NORTHEASTERN CONNECTICUT COUNCIL OF GOVERNMENTS
ENGINEERING PLAN, DRAINAGE REPORT AND WETLANDS REPORT REVIEW
PERTAINING TO
PROPOSED WILLOW HILL EVENTS WEDDING/EVENT VENUE
(ASSESSOR'S MAP 19, BLOCK 18 - LOTS 18A & 18B)
WOLF DEN ROAD
BROOKLYN, CT
(March 17, 2023)

The comments contained herein pertain to my further review of a revised set of plans entitled "Special Permit Application for Wedding/Event Venue for Willow Hill LLC, 459 Wolf Den Road, Brooklyn, Connecticut, Dated: November 30, 2022, Revised: March 8, 2023," prepared by J&D Civil Engineers, LLC and from observations made during a site visit by myself on March 14, 2023.

From: Daniel Blanchette <daniel@jdcivilengineers.com>
Sent: Tuesday, March 21, 2023 2:34 PM
To: Jana Roberson; Syl Pauley
Cc: Gregory Fisher
Subject: Revised Plans for 459 Wolf Den Road
Attachments: 22172 Wineland - Site Plans 2023-03-21.pdf

The following is an itemized response to Syl's second review letter:

DATE: NOVEMBER 30, 2022
SHEET: 6 OF 6

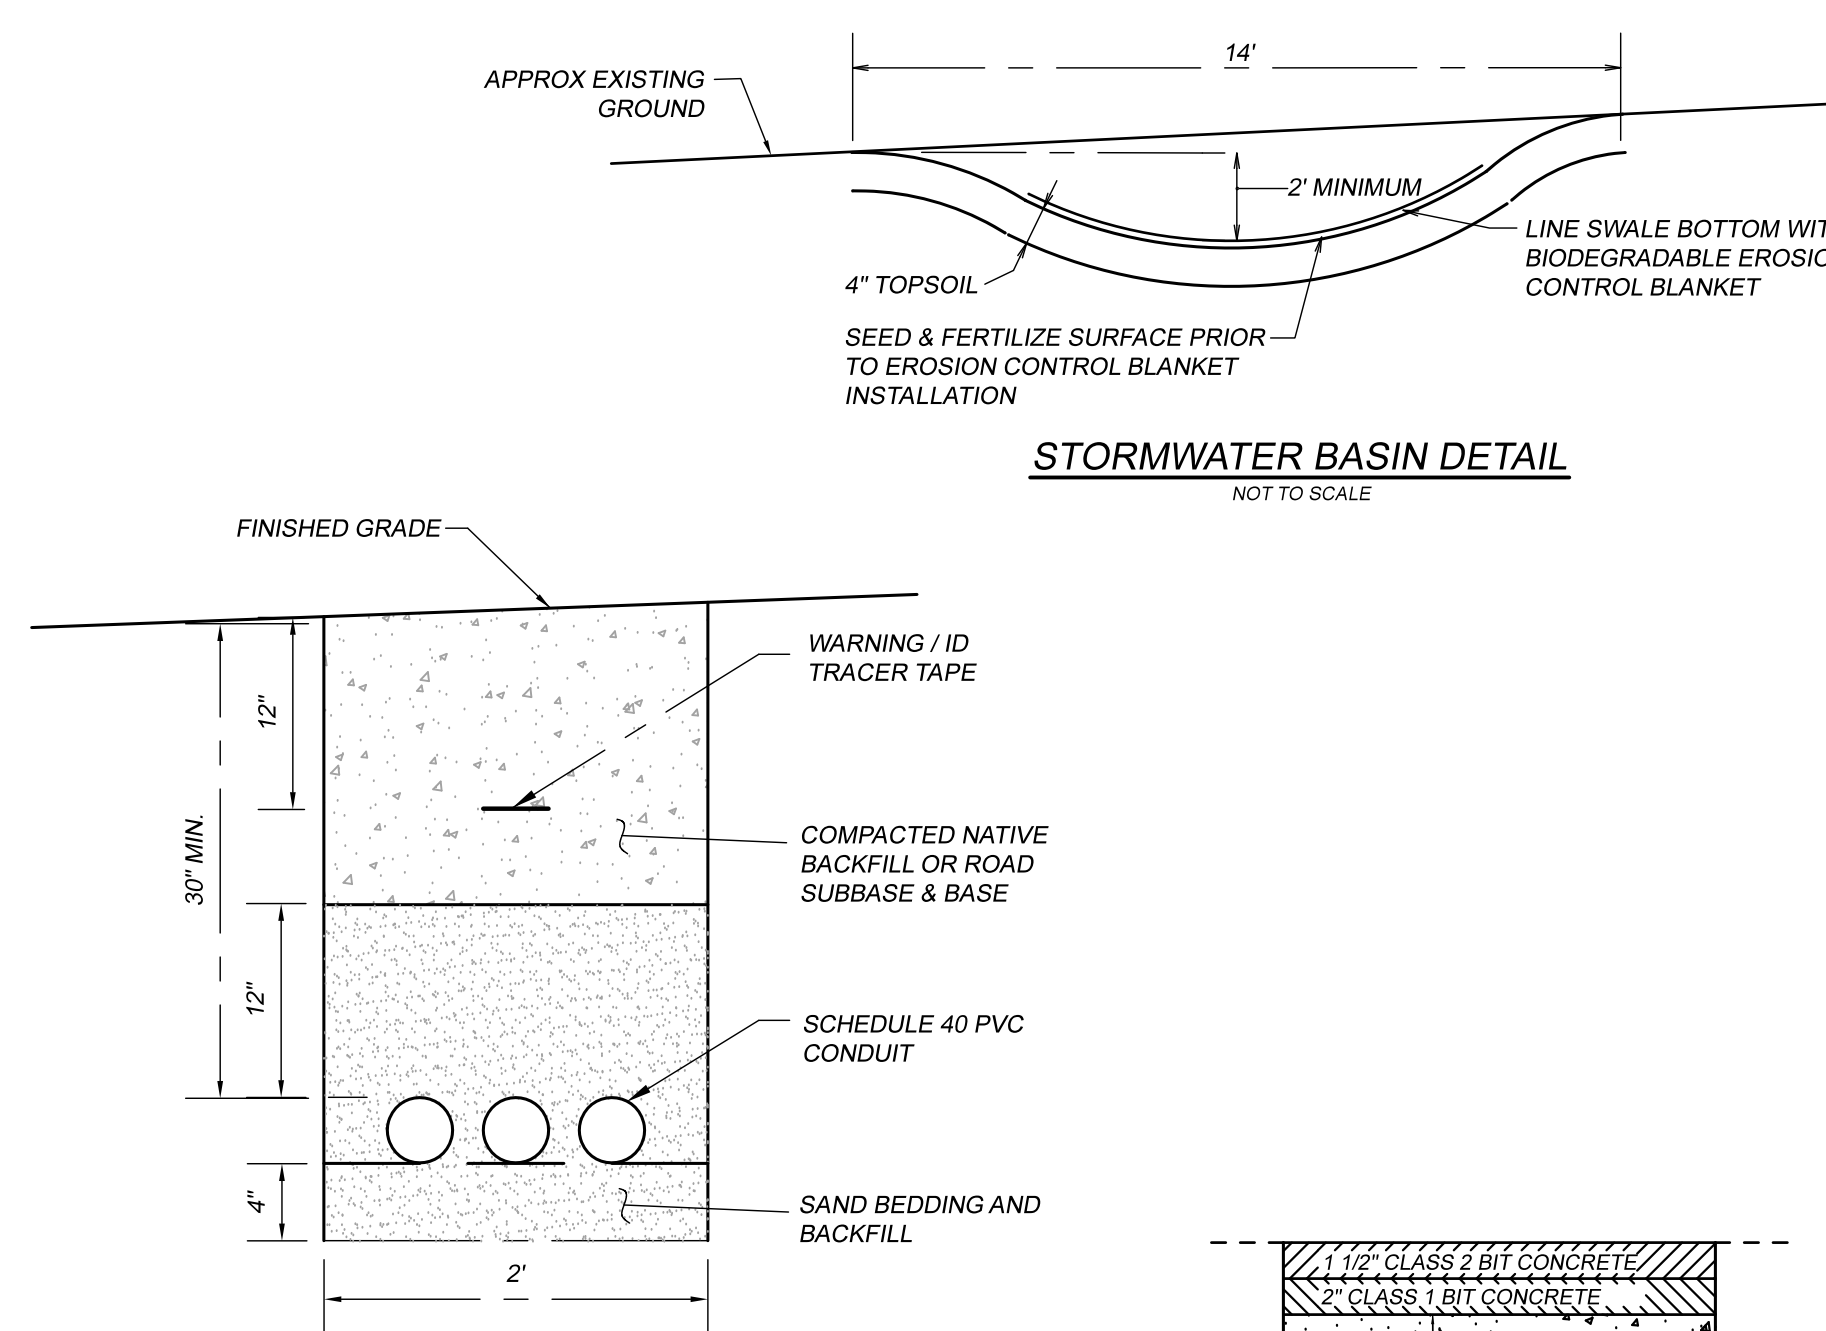
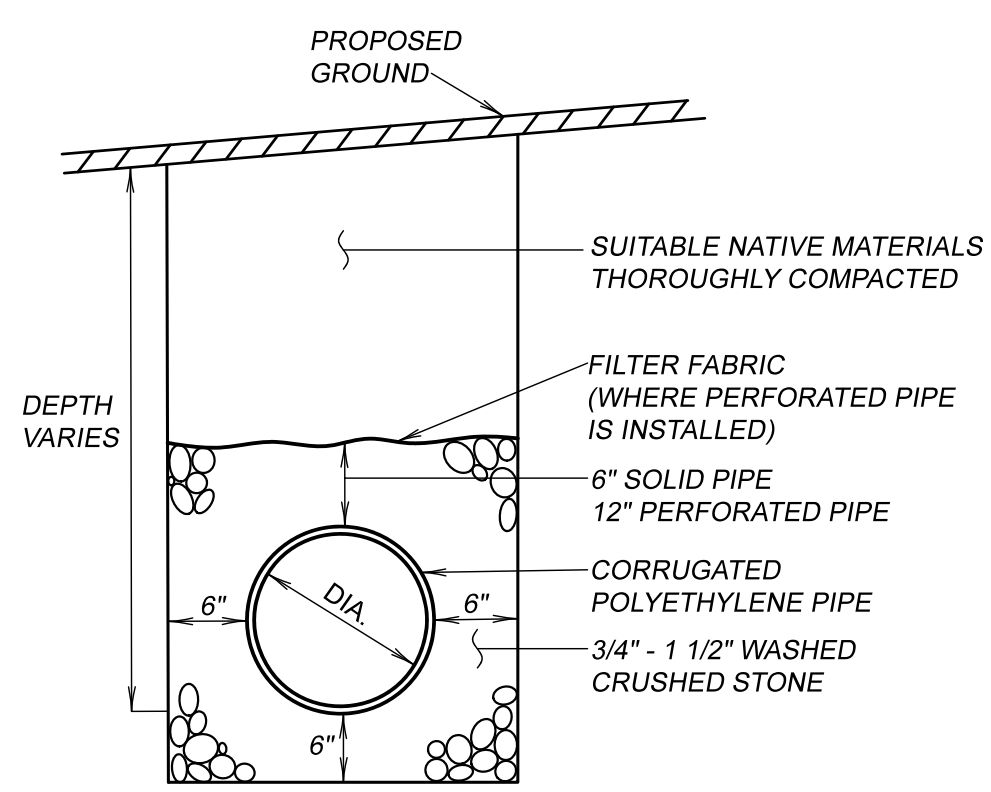
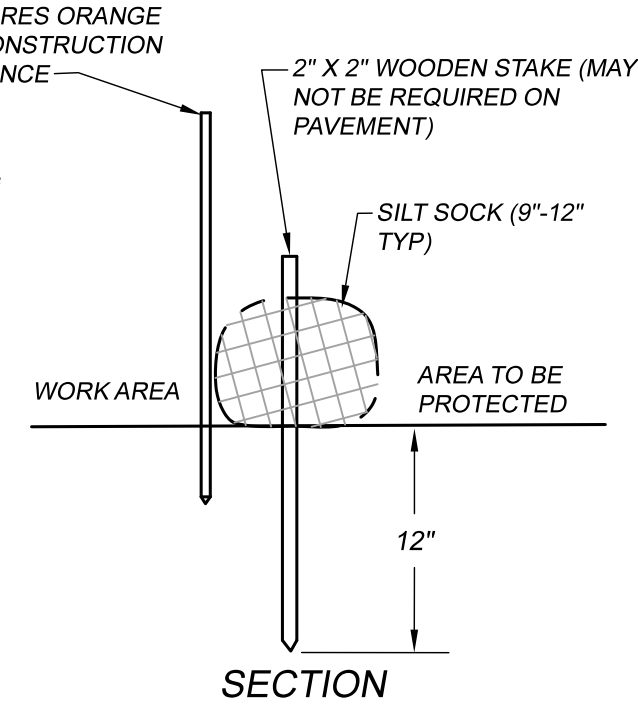
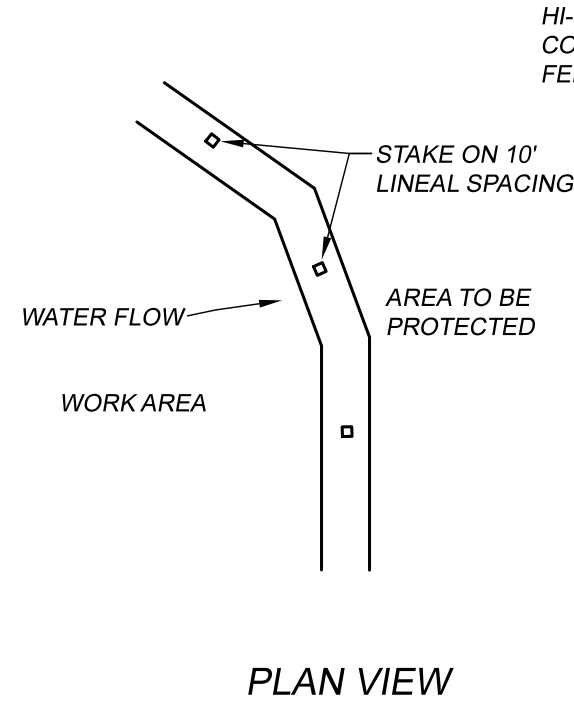
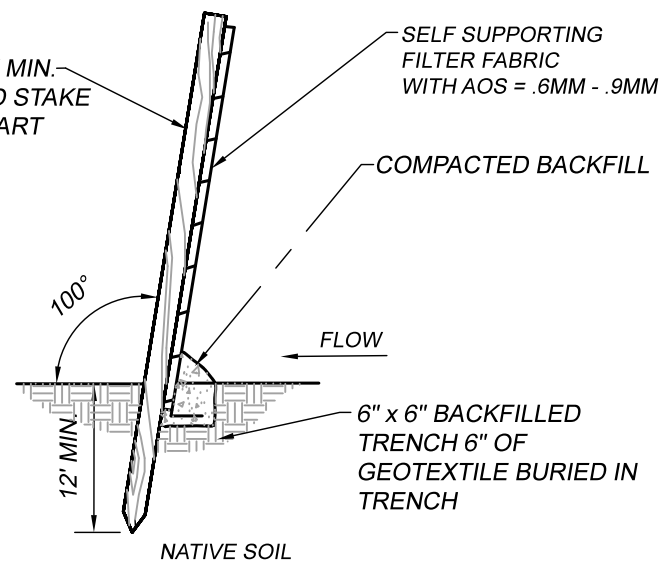
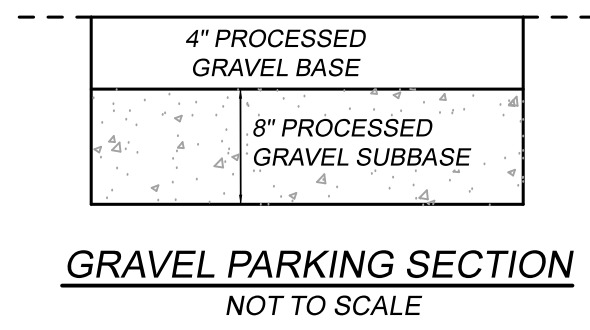
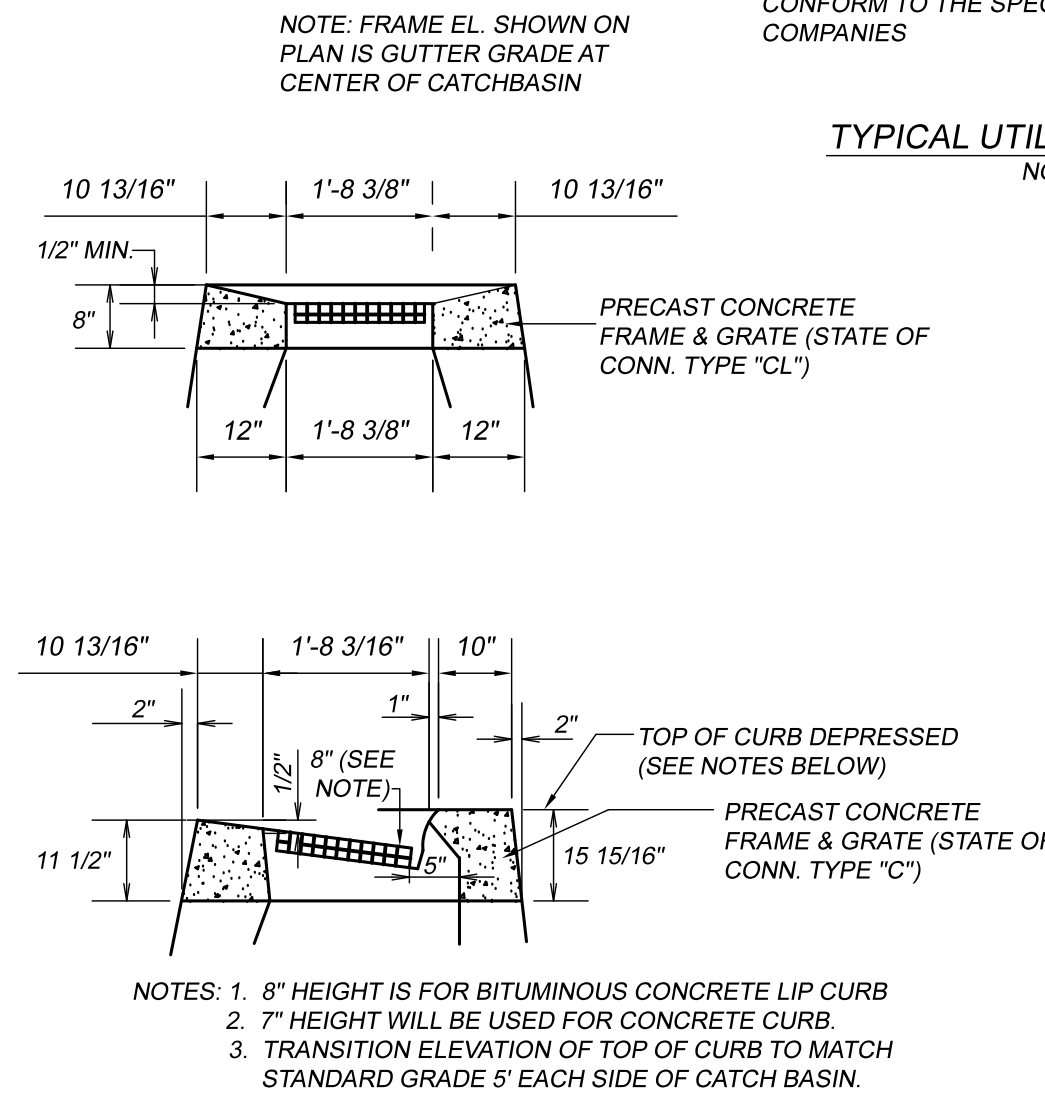
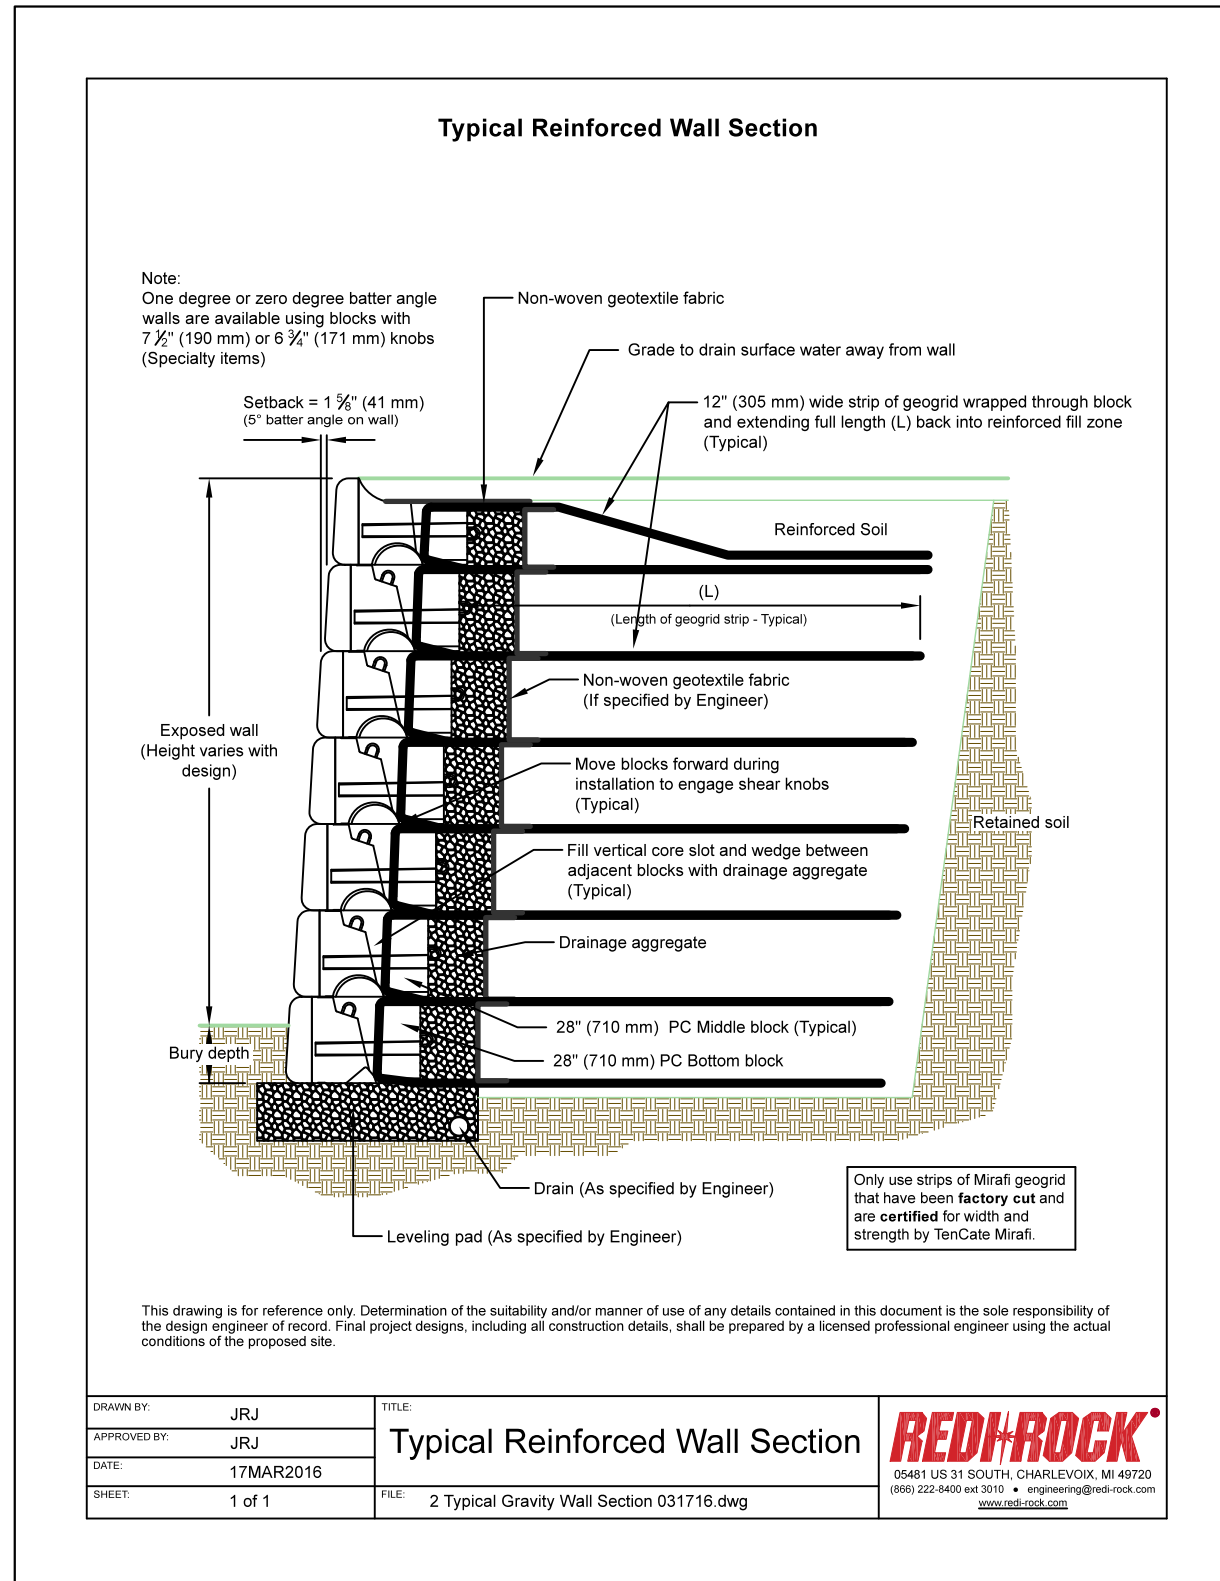
1. The existing driveway to be altered and the proposed driveway are "commercial" driveways, not residential driveways. The "Residential Driveway Section Detail" appearing on Sheet 6 of 6 is not applicable and, furthermore, can be found in the Brooklyn Public Improvement Specifications only for showing construction of a driveway apron. The detail needs to be removed and one showing a driveway cross-section with materials and dimensions that will handle heavy vehicles (buses, fire trucks, delivery trucks, etc.) be added to the sheet in its place and labeled as a "commercial driveway." A commercial apron detail is also required.

5. The "Drainage Pipe Installation Detail" on Sheet 6 of 6 indicates that solid pipe shall have a 6' (feet) cover of crushed stone. This symbol needs to be changed to 6" (inches). Also, the crushed stone needs to be noted as "washed" crushed stone so that fine mineral particles are minimized within the stone matrix.

1. The previous detail for "residential driveway" has been removed from Sheet 6. A cross section for the paved driveway has been added to Sheet 6. Additionally, several dimensions were added to the driveway on Sheet 4. Together, they should contain all the necessary information for construction, such as the example you provided from the Town of Franklin.

5. The detail for drainage pipe installation has been revised.
6. The existing driveway under the deck is shown more clearly.
7. The applicants preference is for pea stone, and they are aware it will require more maintenance than typical processed gravel.
